STAFF REPORT: NOVEMBER 14, 2022 REGULAR MEETING

APPLICATION NUMBER: 22-8167

ADDRESS: 12142 BROADSTREET

SCOPE: INSTALL ALUMINUM-CLAD WOOD WINDOWS AND VINYL WINDOWS

December 2022 photo by staff.

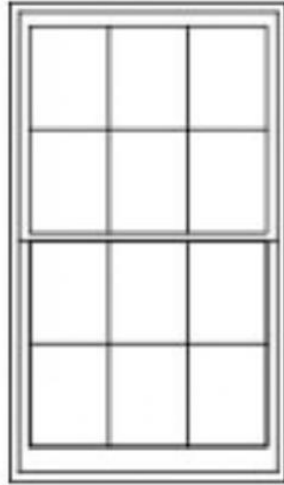
12142 Broadstreet is a two-and-a-half story, brick, Tudor Revival house built in 1927. It faces west onto Broadstreet Avenue. Defining features include prominent, sharp gables on the front façade and projecting entrance bay, a gambrel roof, decorative brickwork on the entrance bay, and a raised, landscaped berm on the front (west) side of the house. The windows, previously important features, are now missing; it is unclear if the doors remain.

- The leaded glass casement windows formerly on the west elevation provided “textural interest,” as described in the Elements of Design, and thus are a defining feature. Installing sash windows at this location does not provide the same “textural interest” and is therefore not appropriate.

Staff recommends that the Commission issue a *Denial* of the proposed window installation on the north, east, and south elevations, and the proposed installation of the two windows above the front entrance bay, as the proposed work does not meet the Secretary of the Interior’s Standards for Rehabilitation, in particular:

Pinnacle aluminum-clad wood windows. Note that the application proposes six-over-one windows, not the six-over-six windows shown in the sketch. *Image:* <https://www.windsorpinnacle.com/clad/double-hung-glide-by>

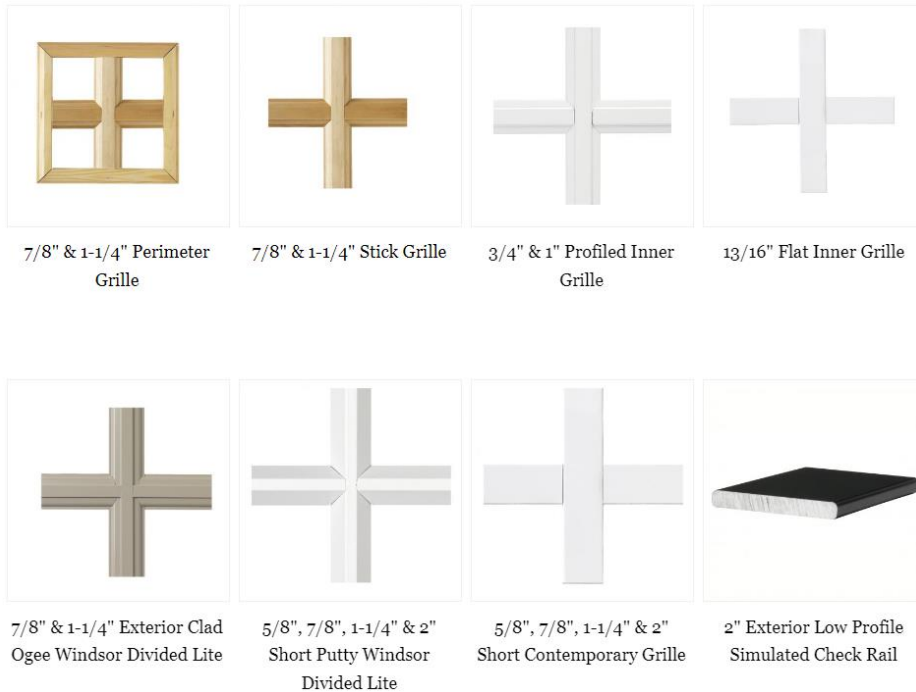
- As the windows on the front façade are missing, dimensions or detailed photos are not available. However, from the images provided on the Pinnacle product website, staff suggests that the proposed windows are dimensionally appropriate (with an exception, as described under Issues, below). Of the simulated muntins shown on the product website, some are more appropriate than others.
- It is unclear from the application and from the site visit photos if the historic wood mullions between windows on the front façade remain. Standard #2 states that they should not be removed.

- The choice of simulated muntins and sash color shall be subject to approval by staff.
- Historic wood mullions on the front (west) façade will be preserved or, if missing, replicated.
